Subject: USACE CONTRACT NO. DACW-33-94-D-0002
TOTAL ENVIRONMENTAL RESTORATION CONTRACT (TERC)
TASK ORDER NO. 017 – NEW BEDFORD HARBOR SUPERFUND SITE OU-1
FINAL EVALUATION OF SIDEWALL LINER ALTERNATIVES FOR CDF C AND PCB
LEAKAGE RATES MODELING

ANNOTATED RESPONSES TO REVIEW COMMENTS
ON THE EVALUATION OF SIDEWALL LINER ALTERNATIVES AND PCB LEAKAGE RATES
MODELING FOR CDF C

**FINAL
TECHNICAL MEMORANDUM
SHEET PILE WALL WITH HALF DIKE DESIGN
EVALUATION OF SIDEWALL LINER ALTERNATIVES
AND
PCB LEAKAGE RATES MODELING
CONFINED DISPOSAL FACILITY (CDF) C
NEW BEDFORD HARBOR SUPERFUND SITE**

FIGURE 7-1
 NEW BEDFORD, MASSACHUSETTS
 CONFINED DISPOSAL FACILITY C
 CDF C WITH PREFERRED
 LINER SYSTEM
 NOT TO SCALE | 17FC101F.DGN

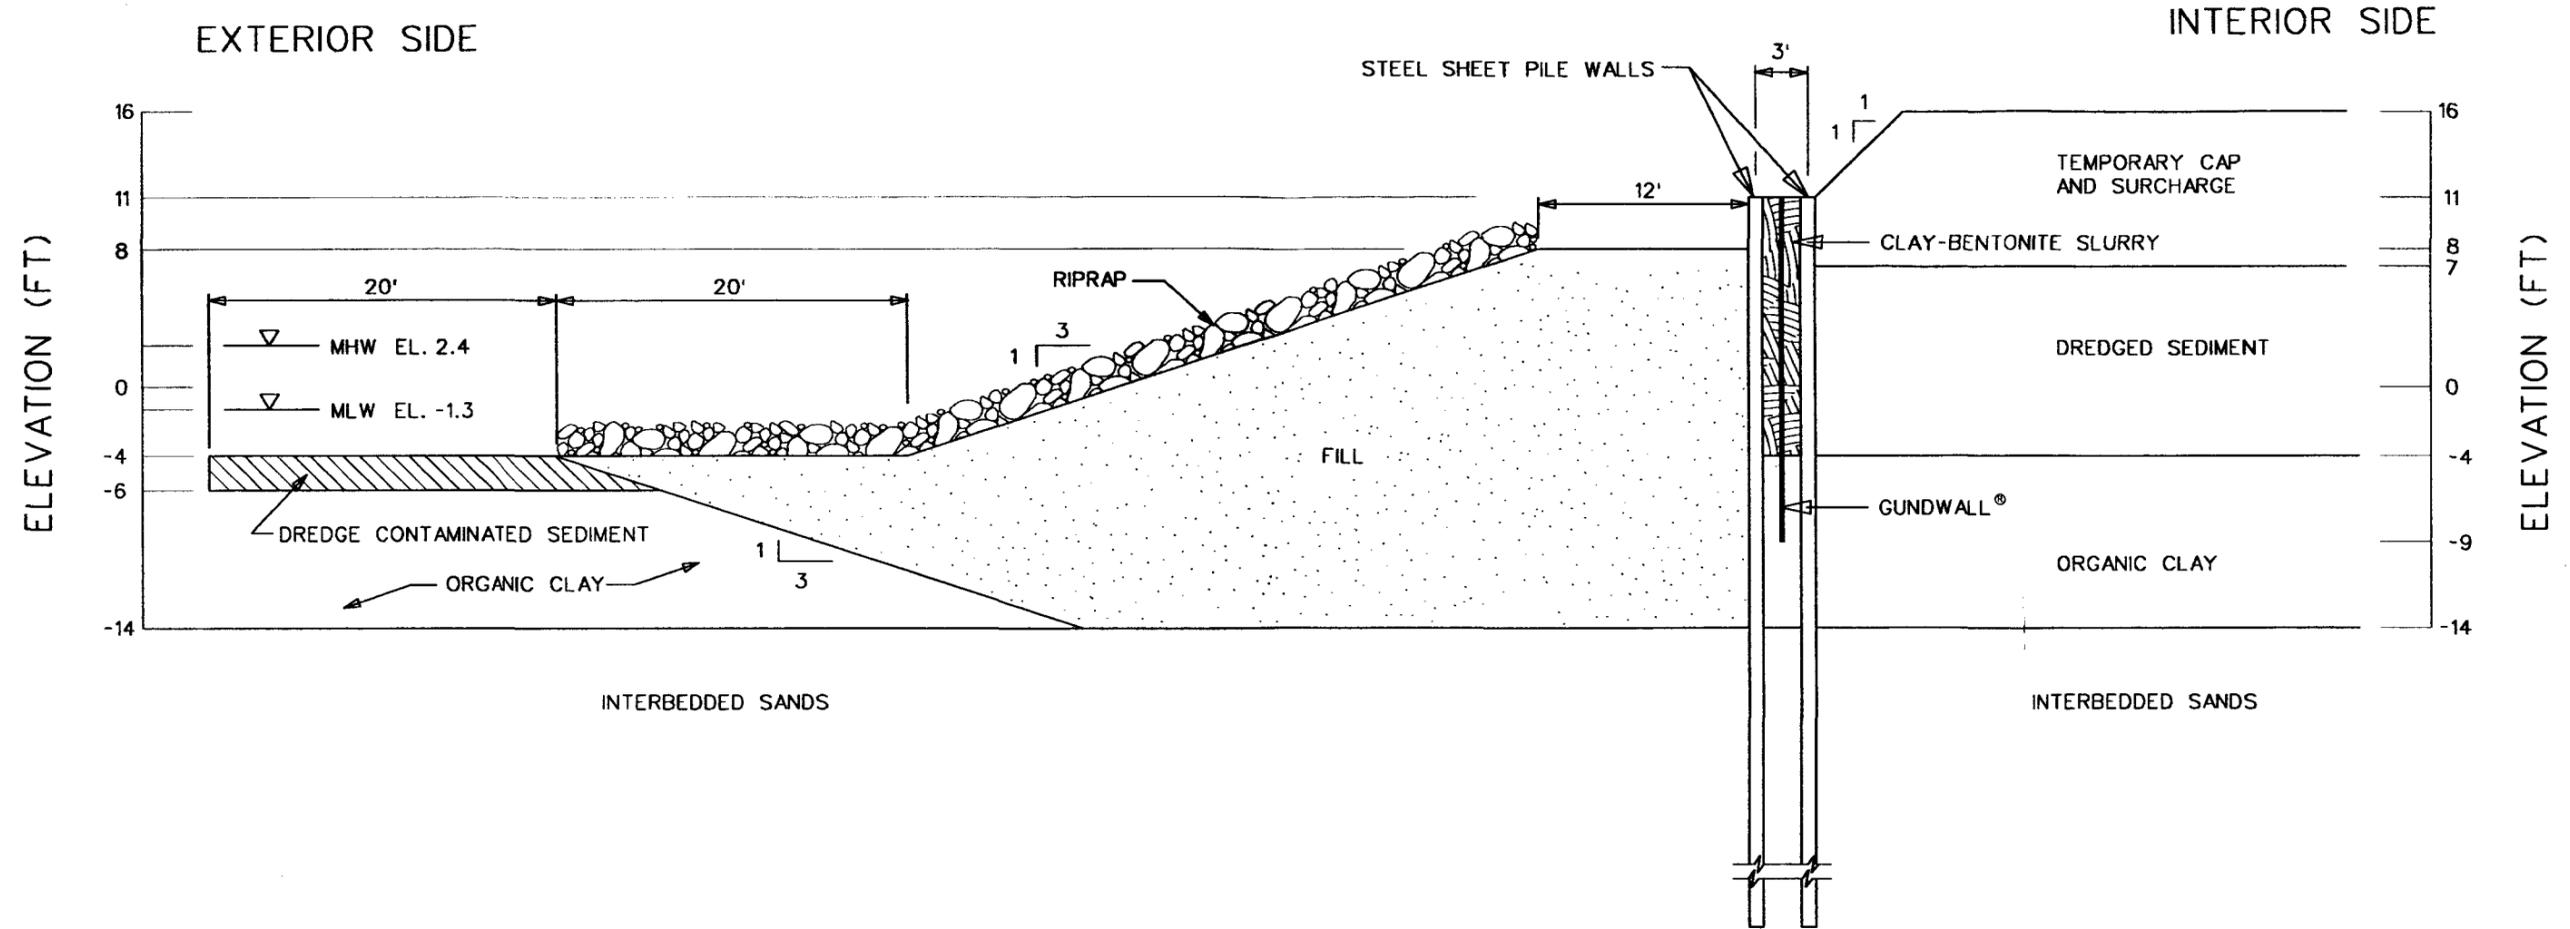
Comment 3: Figure 7-1 – The slurry is only shown to the organic clay layer. Is this shown low enough?

Comment 8: Page 15 – In step 7, it says "may". It would seem from discussions that desiccation is a big deal and something undesired, therefore, shouldn't it be "will" instead of "may". Therefore, it should be included in Figure 7-1 and in the cost estimate. At the very least, it should be stated on the cost estimate as a contingency in either a lump sum allowance, a unit cost (if known), or an appropriate percentage. Contingency is missing to begin with and should be added to the estimate.

Response: This figure presents a preliminary conceptual design where the slurry wall would fill the space between the two steel sheets, and the GundWall® would be inserted into the slurry wall and keyed five feet into the organic clay creating the most “impermeable” vertical barrier. In reality, there would likely be some mixing of the clay-bentonite slurry and the underlying organic clay. The degree of mixing is not known at this preliminary stage of the design.

Response: The material used to fill the space between the two sheet pile walls is still undetermined. It may be a clay-bentonite, cement-bentonite, or clay-cement-bentonite slurry. Because of the number of variables, it is not possible to say definitely if desiccation will or will not be an issue. Therefore, the best statement to make is that a cap "may" be installed over the clay-bentonite slurry wall to prevent possible desiccation. This cap has not been included as a contingency in the cost estimate since it is not known if it is needed.
